Request of Class II Permissive Change

Company name: Anker Innovations Limited

FCC ID: 2AOKB-A3102V

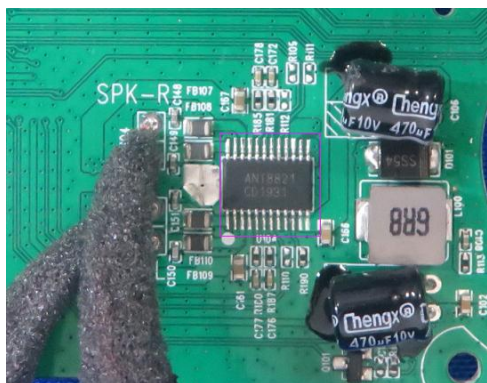
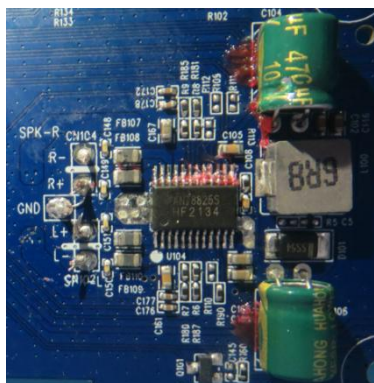
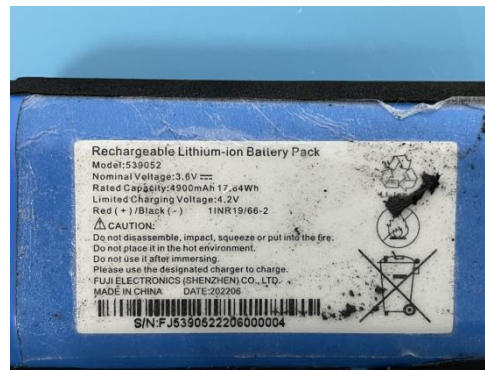
- (1) Changing the Amplifier IC chip "ANT8821" to "ANT8825S".
- (2) Change the cell capacity from "4400mAh" to "4900mAh"
- (3) Change the cell voltage from "3.7V" to "3.6V"
- (4) Added inductance "1.2K"*5
